NUMBER: 23-011-14 REV. A

Left Rear Sliding Door Weatherstrip Seal Sticks Out At Bottom Of C-Pillar Door Opening

This bulletin involves replacing the left rear C-pillar cut line sliding door seal.

2014 RT Caravan / Town & Country

Fig. 1 Symptom Condition Area Of Concern

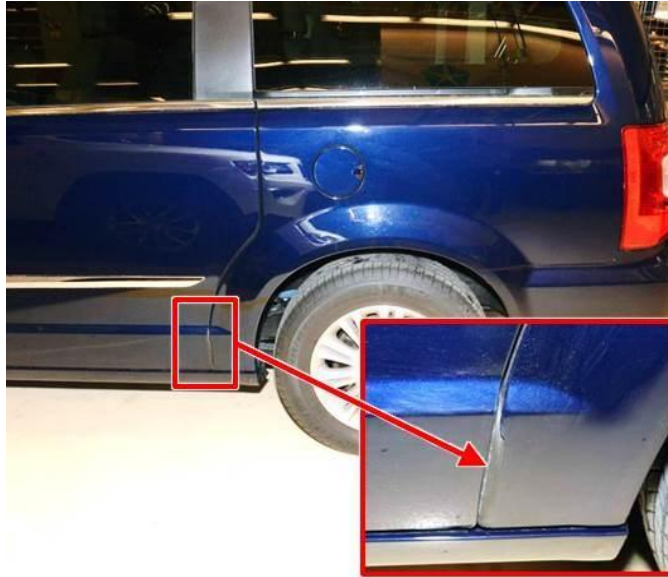
Some vehicles may have a left rear sliding door weatherstrip seal that sticks out along the C-pillar side of the door opening as shown in (Fig. 1).

1. ****Is the left rear sliding door weatherstrip seal sticking out along the C-pillar side of the door opening as shown in (Fig. 1)?**
 - a. YES >>> Continue with **Step #2**.
 - b. No >>> No further action is required. This bulletin does not apply.**

Fig. 2 Door Weatherstrip Seal Replacement

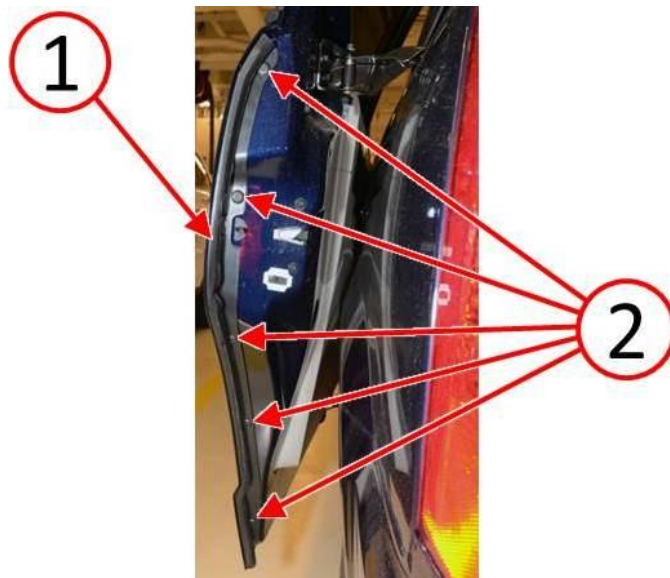
2. Replace the weatherstrip seal on the left rear sliding door with the seal specified in the **PARTS REQUIRED** section of this bulletin (Fig. 2).

Qty.	Part No.	Description
1	68078281AC	SEAL, Rear Door, C-Pillar Cut Line, Left

Fig. 3 Symptom Condition Corrected

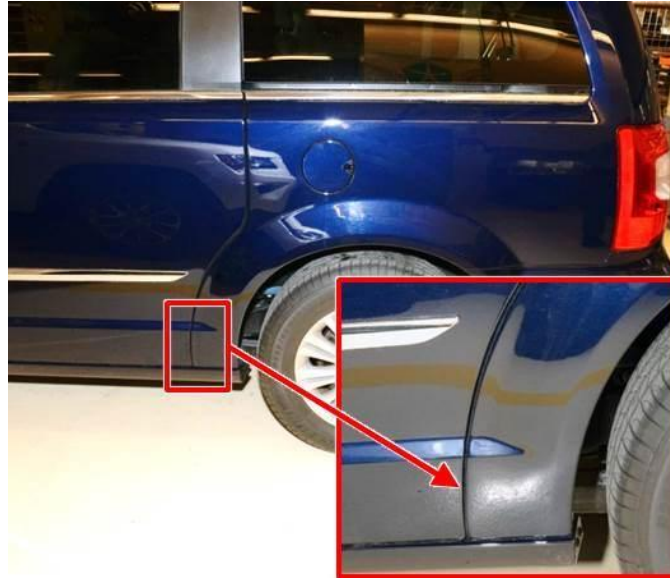
3. Verify that the symptom/condition has been corrected as shown in (Fig. 3).
